**SECTION 009113
ADDENDUM NUMBER 3**

1.02 PROJECT: GRAHAM CREEK AG BUILDING

Re: Graham Creek Ag Building - RFI responses to questions received in writing, Addendum 03

SITE GRADING PLAN

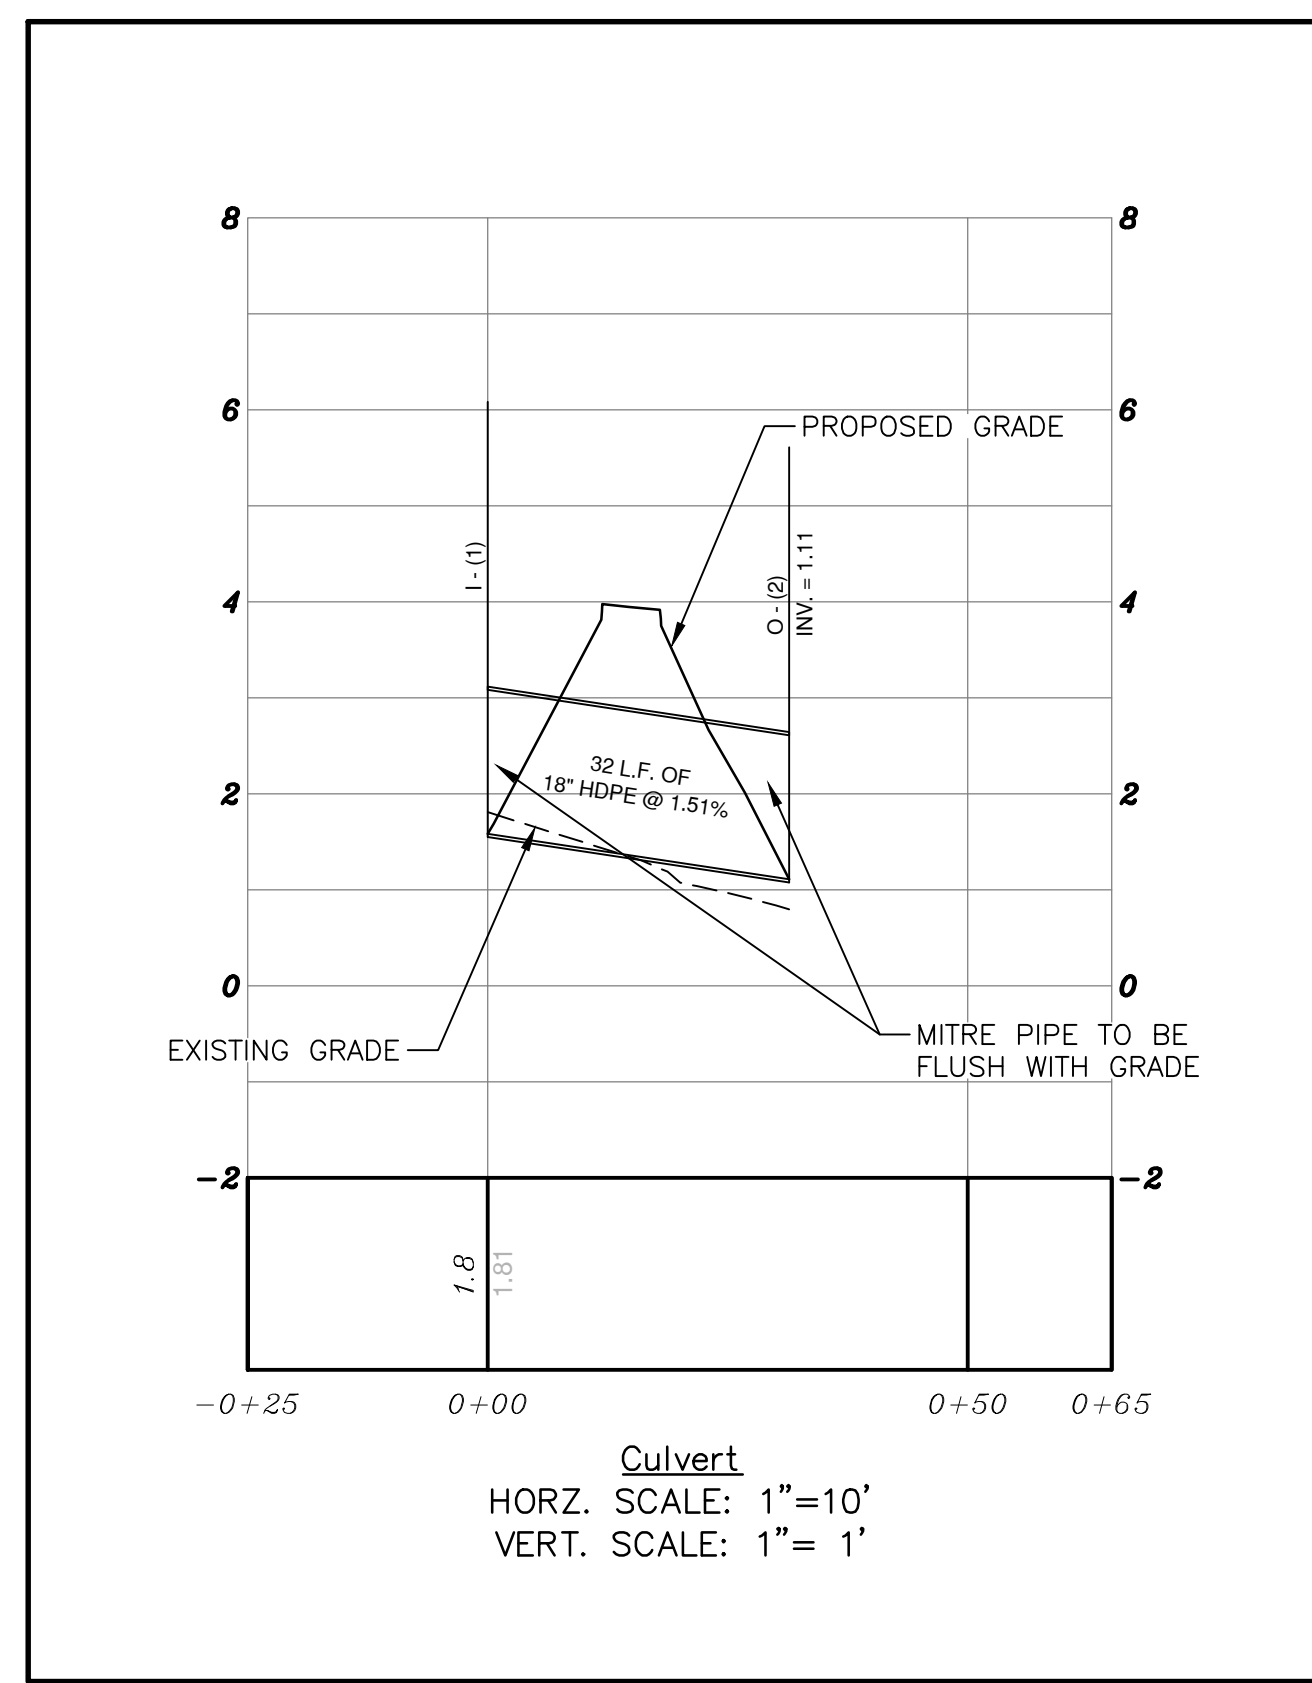
- 21) Please provide a civil drawing showing grades and the new building elevations.
 - a) Refer to the Site Grading Plan (LG100) for the FFE and grading surrounding the building.

1 BUILDING WALL DETAILS
1/2" = 1'-0"

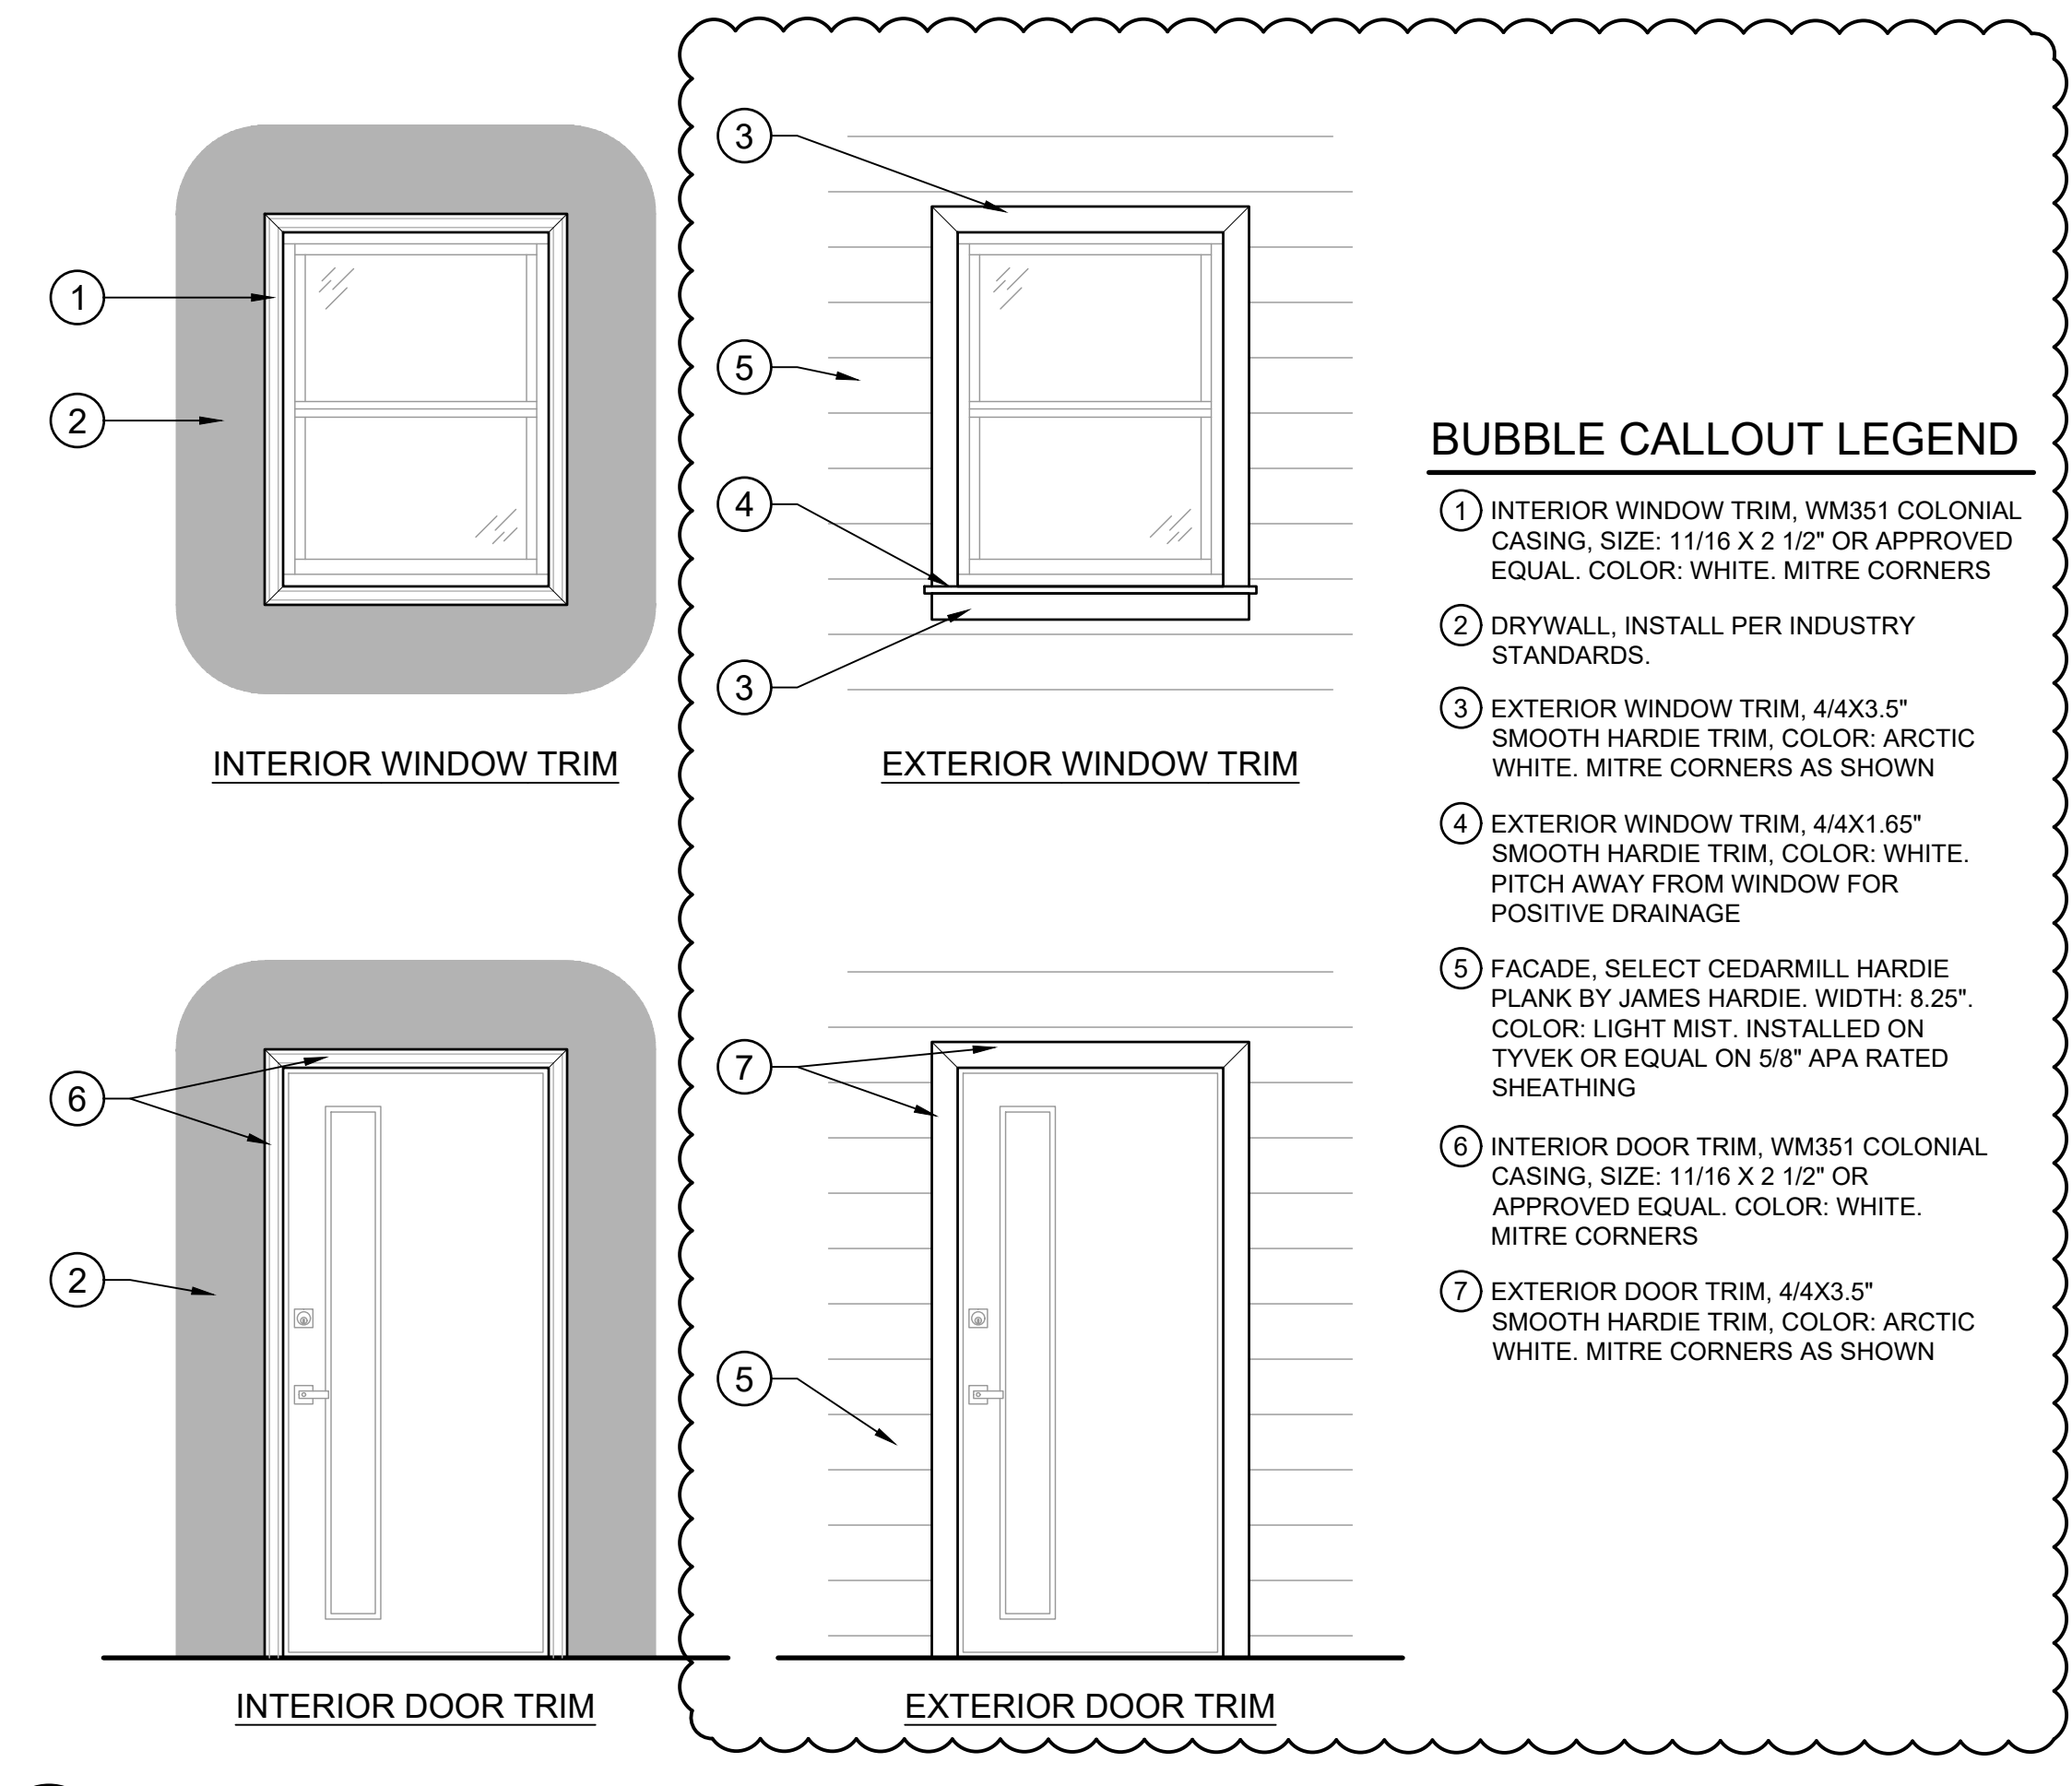
- a) Yes. Hardie Trim will need to be added between the rafter tails. Refer to Building Wall Details on sheet AR501 for details.
- 26) Per conversation at pre-bid, please advise if it would be acceptable to stick frame the roof system in lieu of installing prefabricated trusses.

- a) No. The structural engineer advised that trusses are preferred for this building.
- 27) According to note 9/AR501 of the bid documents, v-groove soffit denote. Would it be acceptable to install T1-11 in lieu of the v-groove?

- a) Yes. The drawings have been updated to represent this change. Refer to Building Wall Details on sheet AR501 for details.
- 28) Please confirm that all tap fees are by the owner.

- 31) Is soffit required?
 - a) No. Refer to Building Wall Details on sheet AR501 for exposed rafter details.
